NO.	REVISIONS	DATE	DESIGN	CHECK
02	REMOVED G686-EF, G687-EF, & G682-AHU, BID OPP. 545-2012	2012/08/31	TMC	CJR
01	UPS AND GAS DETECTION MODIFICATIONS	2011/03/11	TMC	CJR
00	ISSUED FOR TENDER	2010/10/01	TMC	CJR

SOUTH END WATER POLLUTION CONTROL CENTRE
 HEADWORKS UPGRADES
 PANEL LAYOUT
 FDP-G REAR VIEW

CITY DRAWING NUMBER: 1-0102G-A0086
 SHEET: 002
 REV: 02
 SIZE: A1

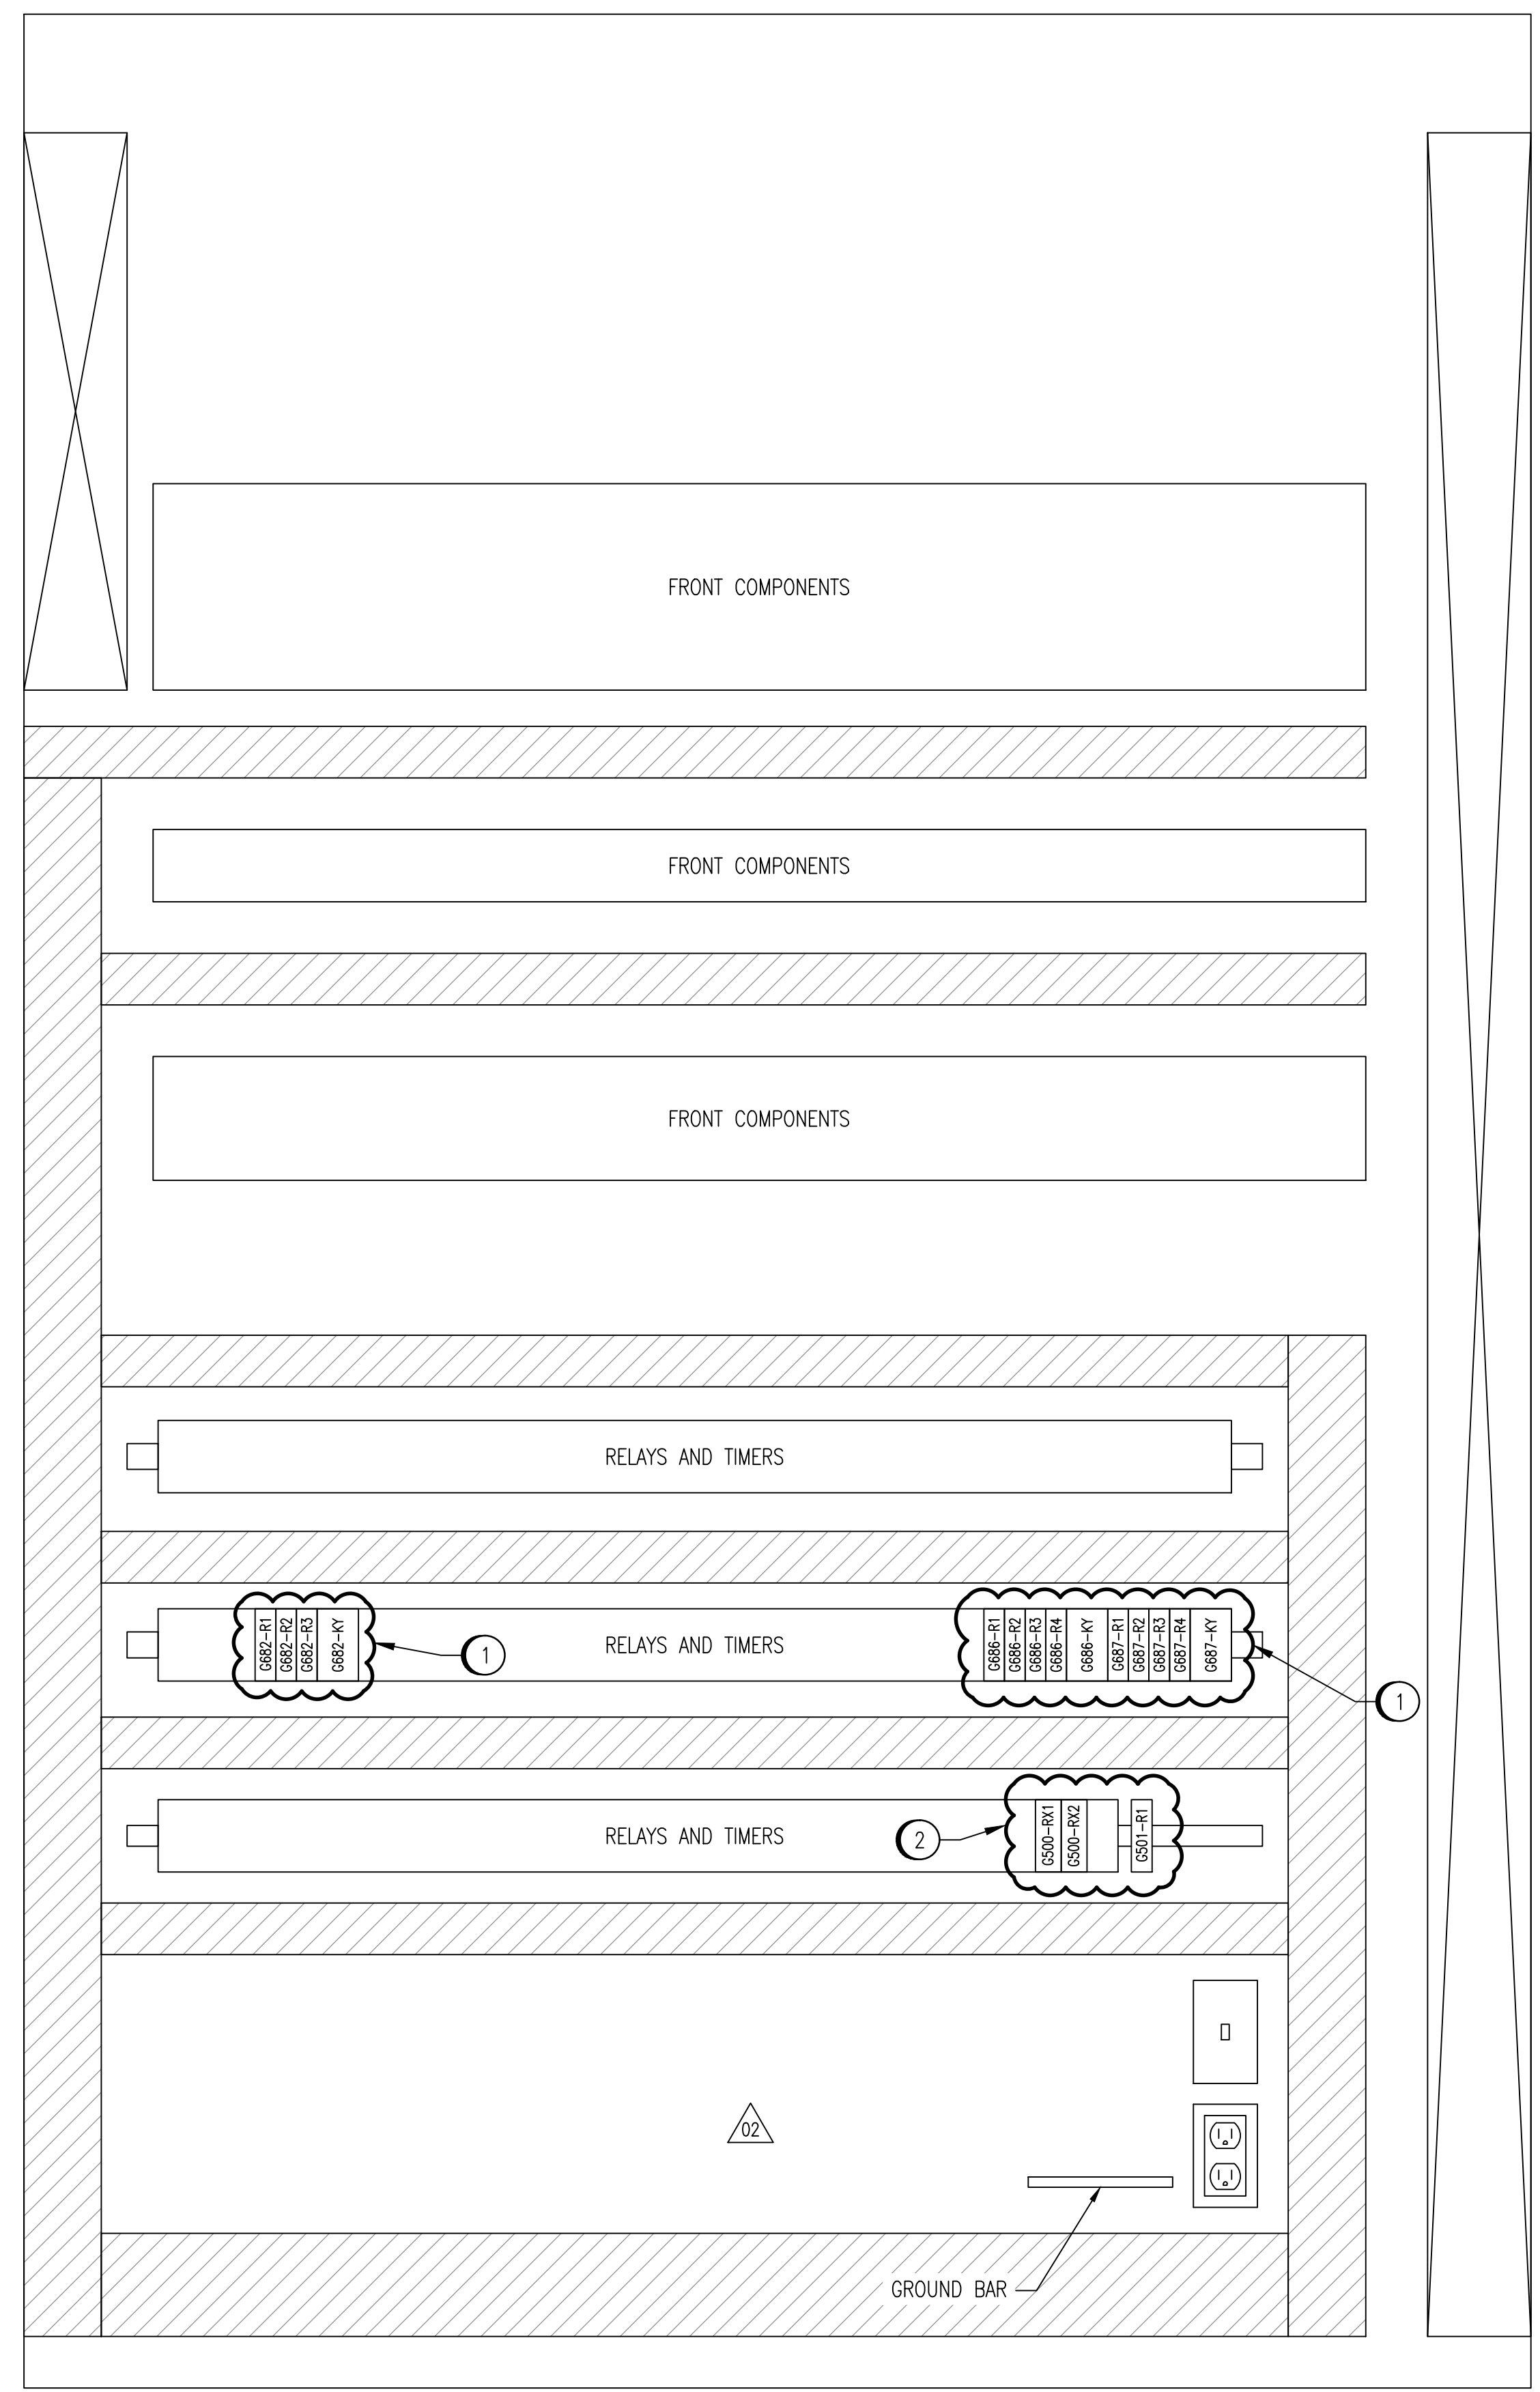
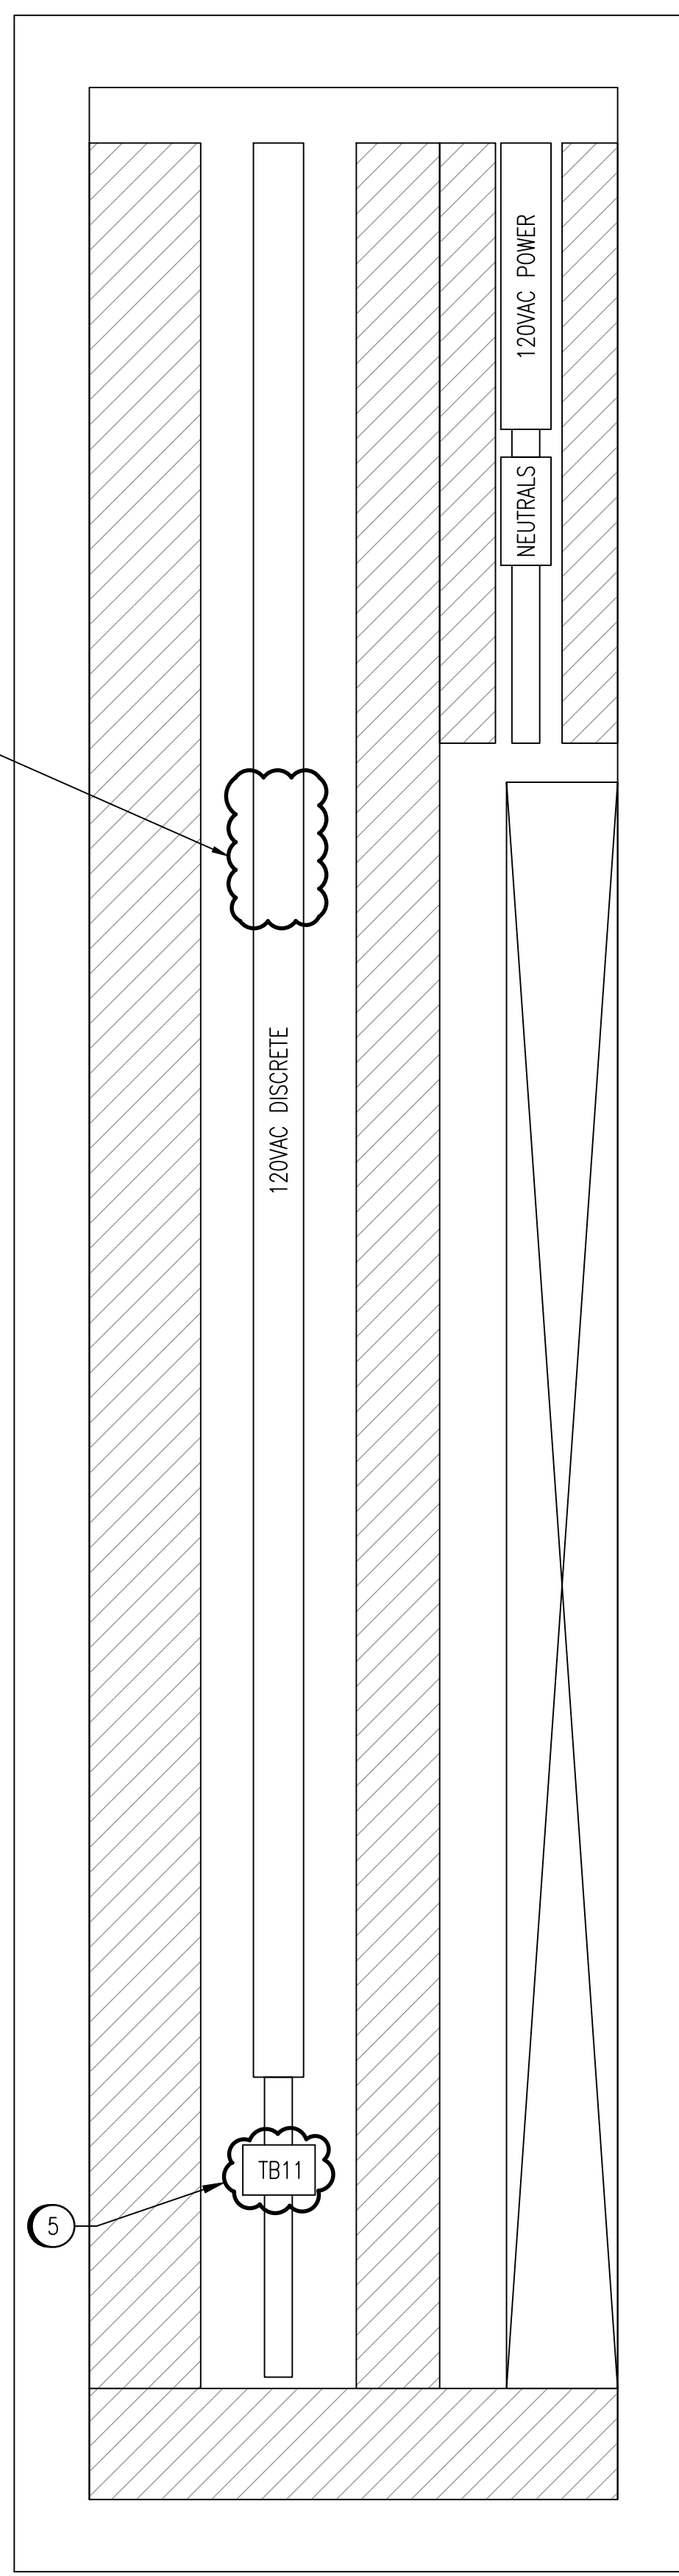
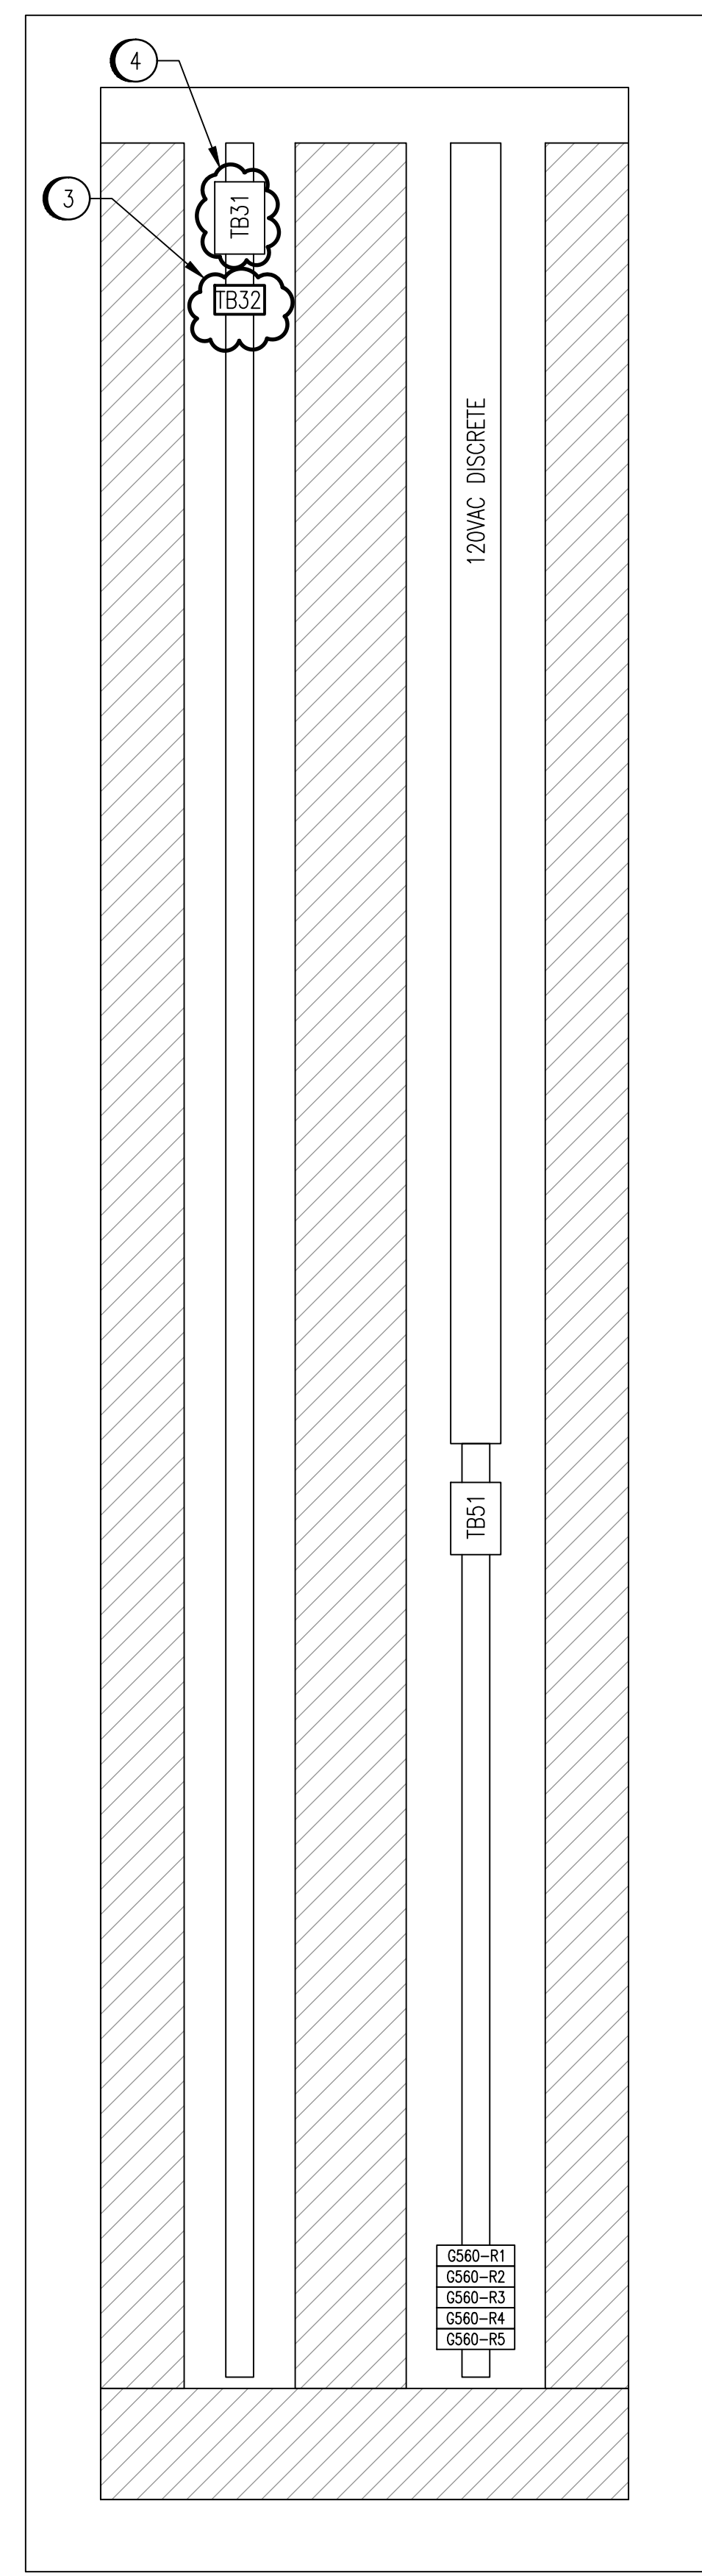
G682, G686,
G687 TERMINALS
①

- CONSTRUCTION NOTES:**
- ① REMOVE WIRING AND DEVICES FROM FDP-G. ENSURE NO OTHER WIRING IS AFFECTED DURING THE REMOVAL PROCESS.
 - ② RENAME AND MODIFY WIRING TO G500-RX1 AND G500-RX2. ADD RELAY G501-R1.
 - ③ ADD TB32 FOR BOILER ROOM SUMP LEVEL TRANSMITTER.
 - ④ ADD TERMINALS TO TB31
 - ⑤ ADD TB11 FOR VENTILATION INTERLOCKS.
